Board of Adjustment Hearing Application - Entry #298

Retaining wall along driveway

RE: Hardship Request for Retaining Wall Encroachment into Required Setback
Property Address: 1726 Horseshoe Ridge Road, Clarkson Valley, Missouri

Memo

Sheet:
RW 2 of 3

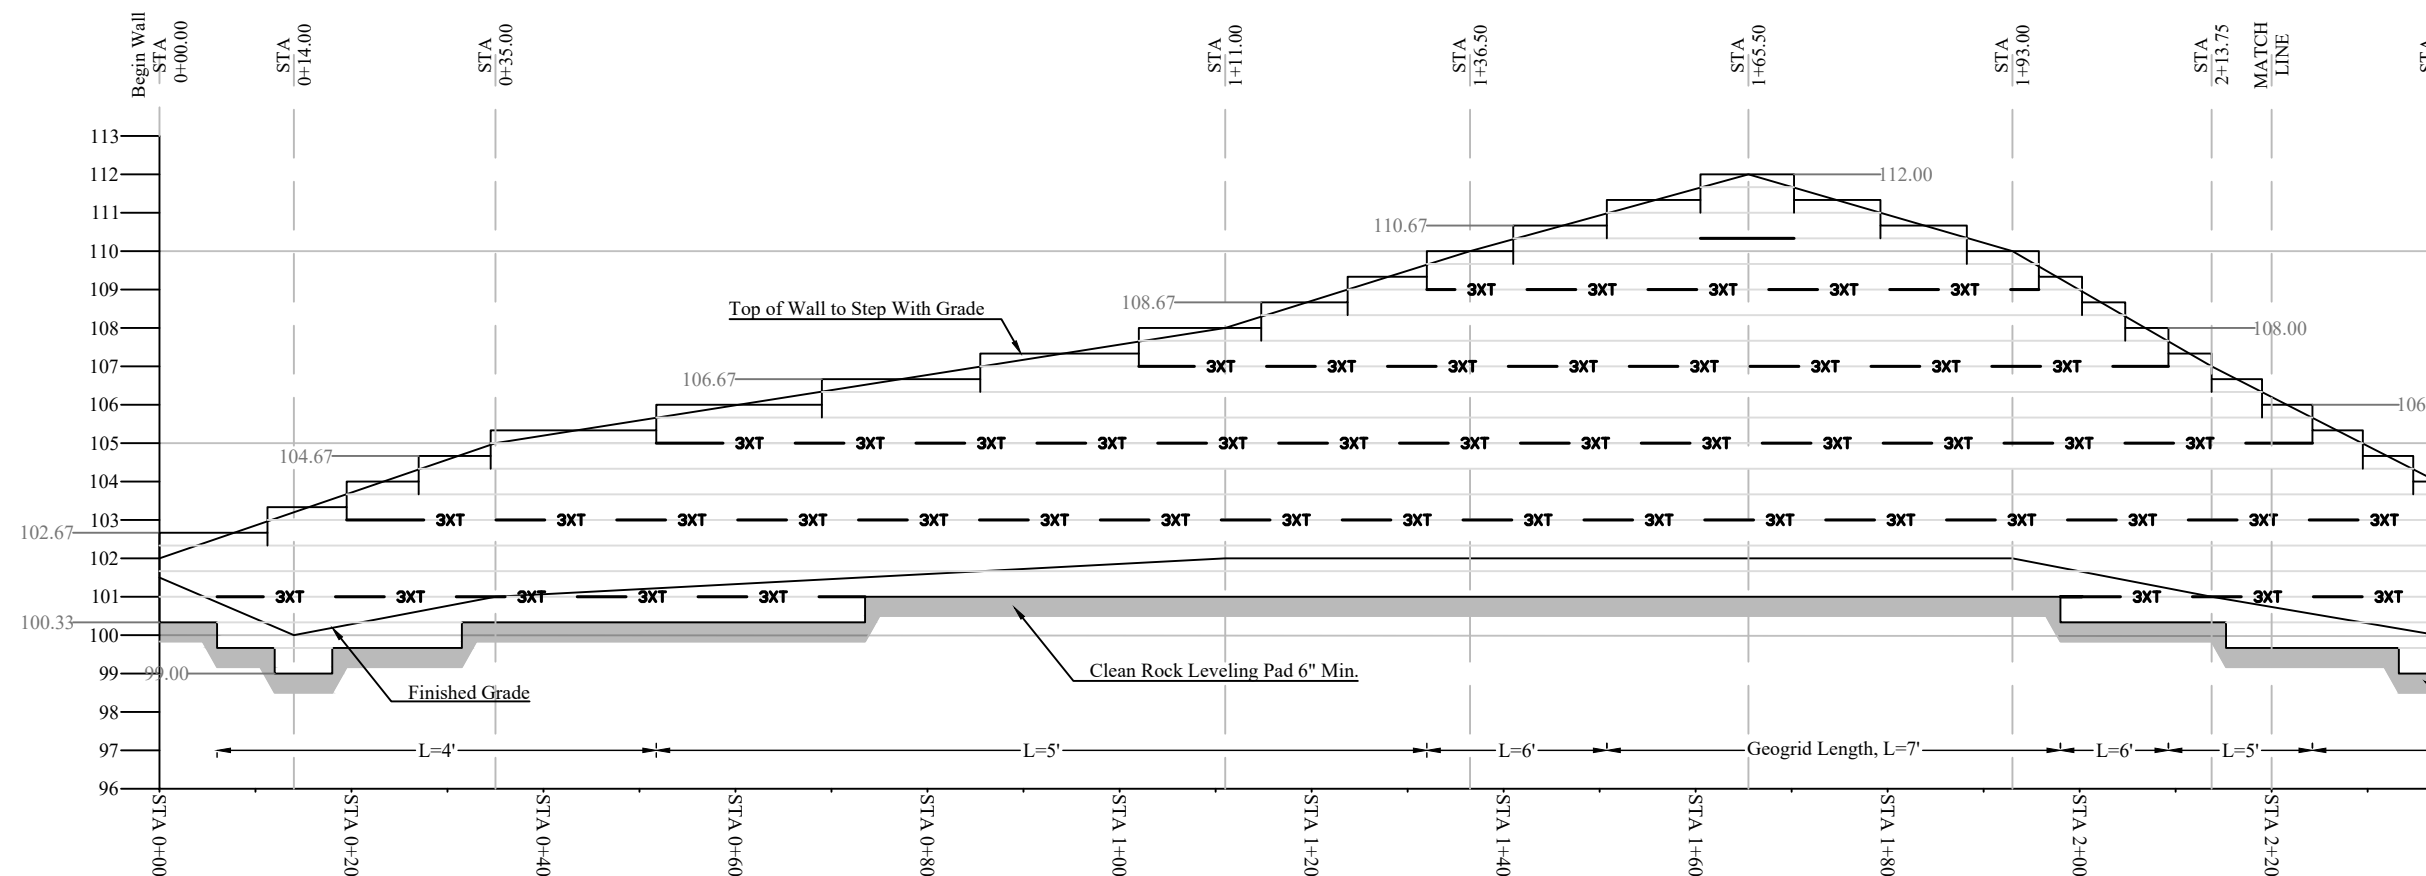
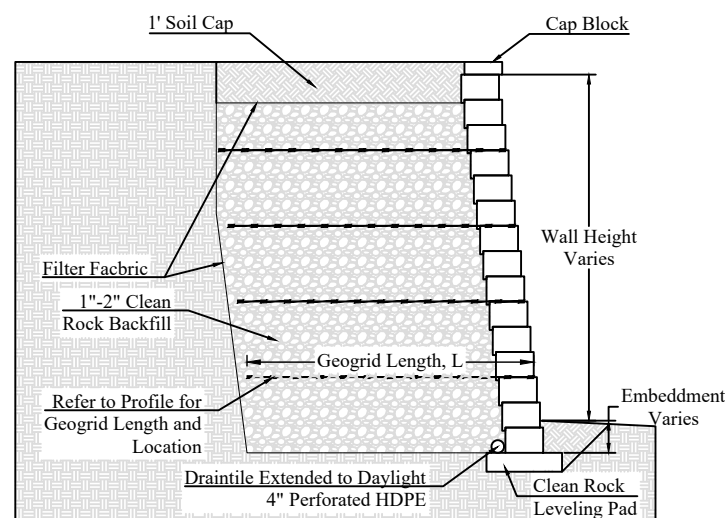
There are two areas where the wall encroaches into the building line setbacks and does not comply with zoning requirements. (I circled in red) The front, or southwest, portion of the wall extends approximately 62 feet into the 75-foot front yard building line setback, with wall heights ranging from 2 to 6 feet. The second area consists of 30 feet of wall, 4 feet in height, located in the northernmost section between approximately the 252 and 272 markers, which encroaches into the 25-foot side yard building line setback. Before I can approve this project, you will need to request a variance from the Clarkson Valley Board of Adjustment (BOA). Please contact the Clarkson Valley office to discuss the application process. I also recommend showing the topography on the site plan submitted to the BOA so the lot elevations are clearly indicated.
